DEVELOPMENT APPLICATION ASSESSMENT REPORT

Application Number:	DA2020/1072
----------------------------	-------------

Responsible Officer:	Anne-Marie Young
Land to be developed (Address):	Lot 1 DP 228962, 1 Drew Place BELROSE NSW 2085 Lot 2 DP 228962, 1 Drew Place BELROSE NSW 2085
Proposed Development:	Construction of a Seniors Housing development, including demolition works, new access driveway and front fence
Zoning:	Warringah LEP2011 - Land zoned R2 Low Density Residential
Development Permissible:	Yes, under Pursuant to SEPP (HSDP)
Existing Use Rights:	No
Consent Authority:	Northern Beaches Council
Delegation Level:	DDP
Land and Environment Court Action:	No
Owner:	Newpro 19 Pty Ltd
Applicant:	Newpro 19 Pty Ltd

Diagram showing the elements that breach the 25% single storey standard (source BBF Planners)

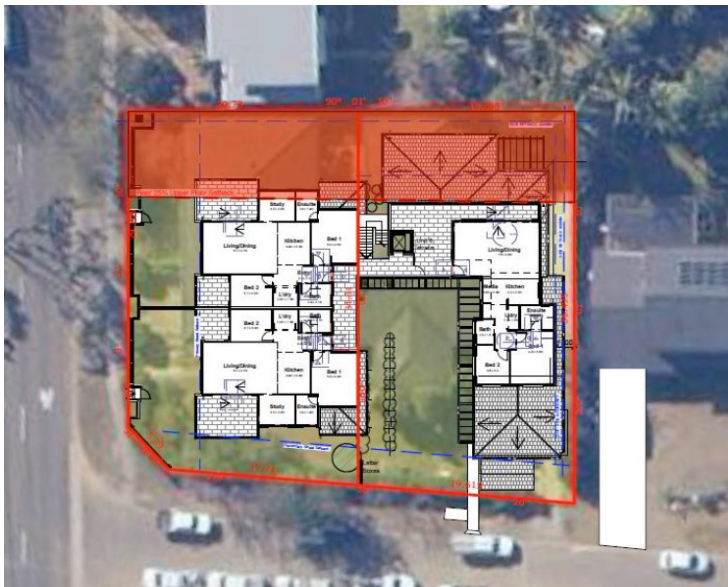
In detail, the study and ensuite to Unit 5 equate to a 15.6sqm area of the 25% site back area which represents a 4.4% breach the control. The applicant notes that these elements do not extend past the rear eastern wall alignment of No. 40 Pringle Avenue, representing the rear yard of this property. In addition, the windows can be suitable screened to prevent directly overlooking should the consent authority consider it necessary to do so. In addition, the applicant notes the following:

The Applicant's justification is generally supported. The elements that breach the first floor 25% rear setback standard will not give rise to unreasonable visual impacts and add interest and articulation to the northern facade.

The balcony to Unit 5 is now a compliant element having been amended to remove a portion of the roof (pergola) that breached the 25% rear setback area. The balcony will not overlook any windows to the neighbouring property at No 40 Pringle Avenue as it is directed to the street frontage and the principle area of private open space to No. 40 Pringle Avenue is located to the rear. Similarly the window to the
